Subject: Waterford 3 SES
Docket No. 50-382
License No. NPF-38
Technical Specification Change Request NPF-38-230
Revision of RCS Cooldown Requirement

**TECHNICAL SPECIFICATION CHANGE REQUEST
REVISION OF RCS COOLDOWN REQUIREMENT**

WESTINGHOUSE REPORT ER-WS-PS-0001, REV 000
IMPROVEMENT OF TECHNICAL SPECIFICATION RCS COOLDOWN LIMITATIONS

FIGURE 3.4-3

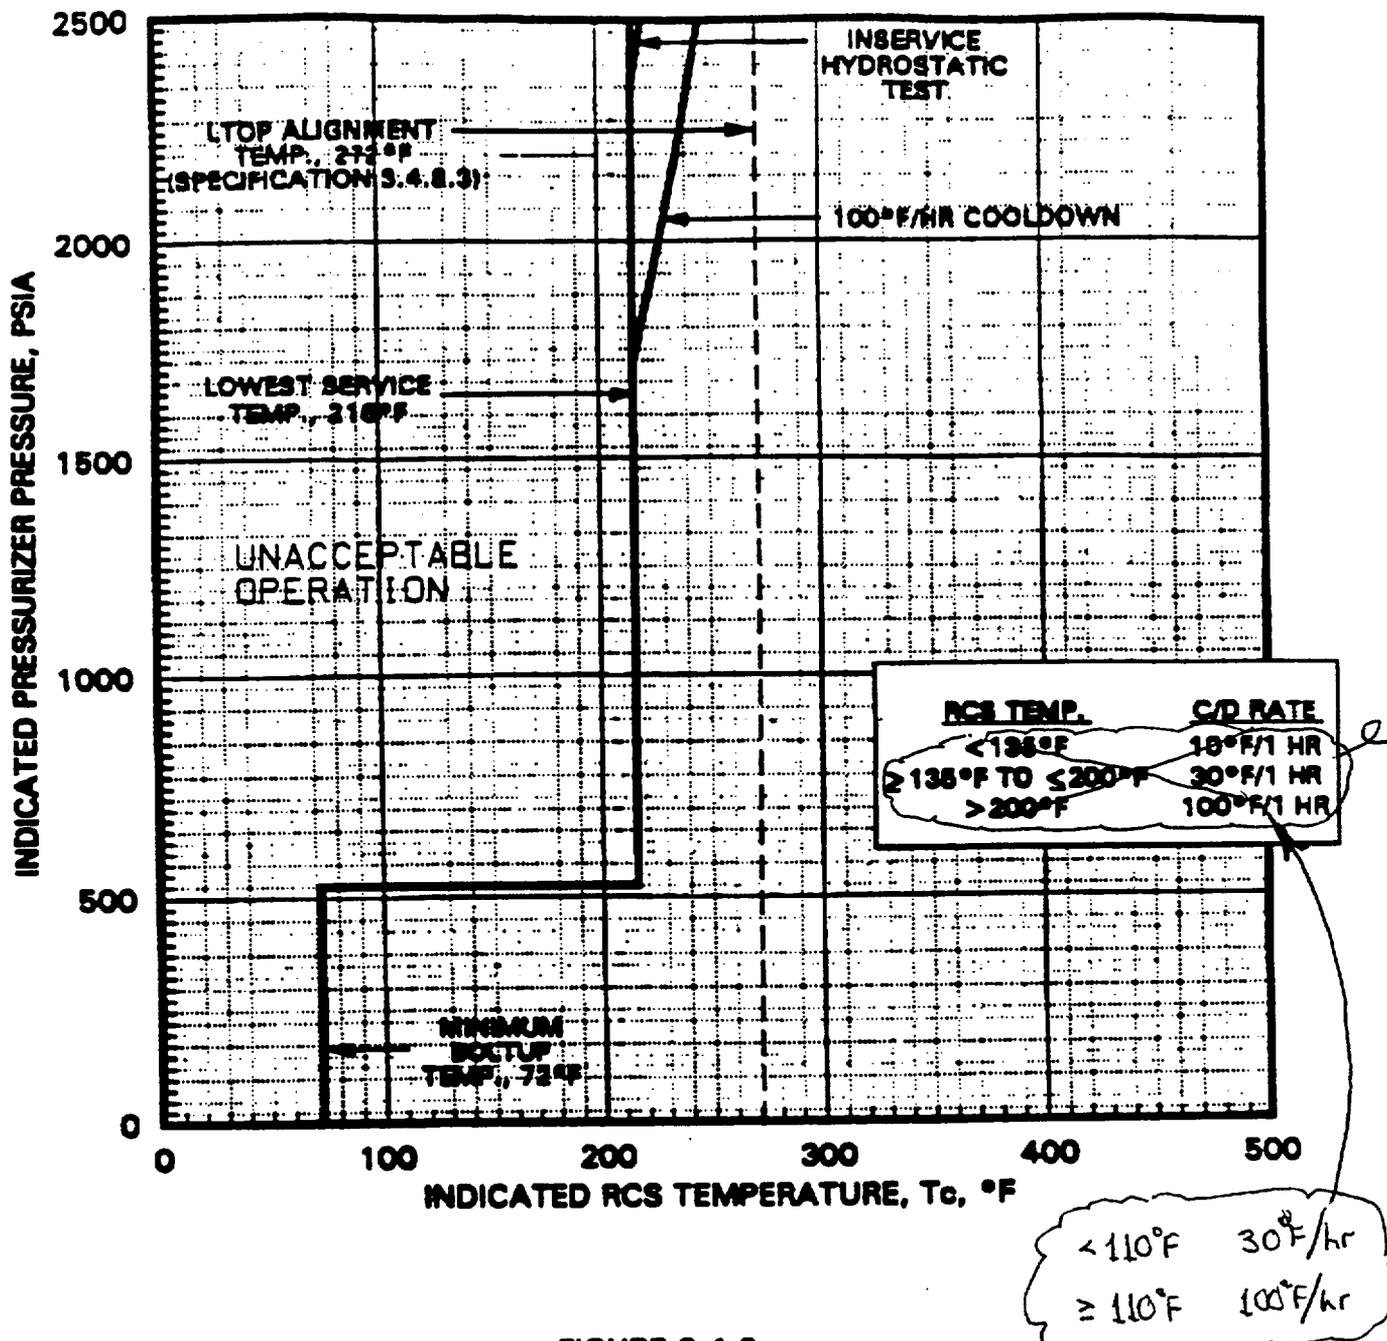
Waterford 3 proposes to amend its Operating License by modifying the Limiting Condition for Operation for Technical Specification (TS) 3.4.8.1 and Figure 3.4-3. The requested changes will revise the Reactor Coolant System (RCS) cooldown limitations to eliminate the 10°F per hour restriction at RCS temperatures below 135°F. The new cooldown rate steps are proposed as 100°F per hour at RCS temperatures down to and including 110°F and 30°F per hour limit at RCS temperatures below 110°F.

- c. A maximum heatup rate of 60°F per hour with Reactor Coolant System cold leg temperature greater than 345°F.
- ~~d. A maximum cooldown rate of 10°F per hour with Reactor Coolant System cold leg temperature less than 135°F.~~

- d g. A maximum cooldown rate of 30°F per hour with Reactor Coolant System cold leg temperature greater than or equal to 135°F and less than ~~or equal to 200°F.~~ 110°F

- e f. A maximum cooldown rate of 100°F per hour with Reactor Coolant System cold leg temperature greater than ~~200°F.~~ or equal to 110°F
- f g. A maximum temperature change of less than or equal to 10°F in any 1-hour period during inservice hydrostatic and leak testing operations above the heatup and cooldown limit curves.

- Eliminate the 10 °F per hour cooldown limit currently at RCS temperatures below 135 °F.
- Extend the 100 °F per hour cooldown limit to be acceptable at RCS temperatures of 110 °F or greater.
- Establish a 30 °F per hour cooldown limit to be applicable at RCS temperatures below 110 °F.
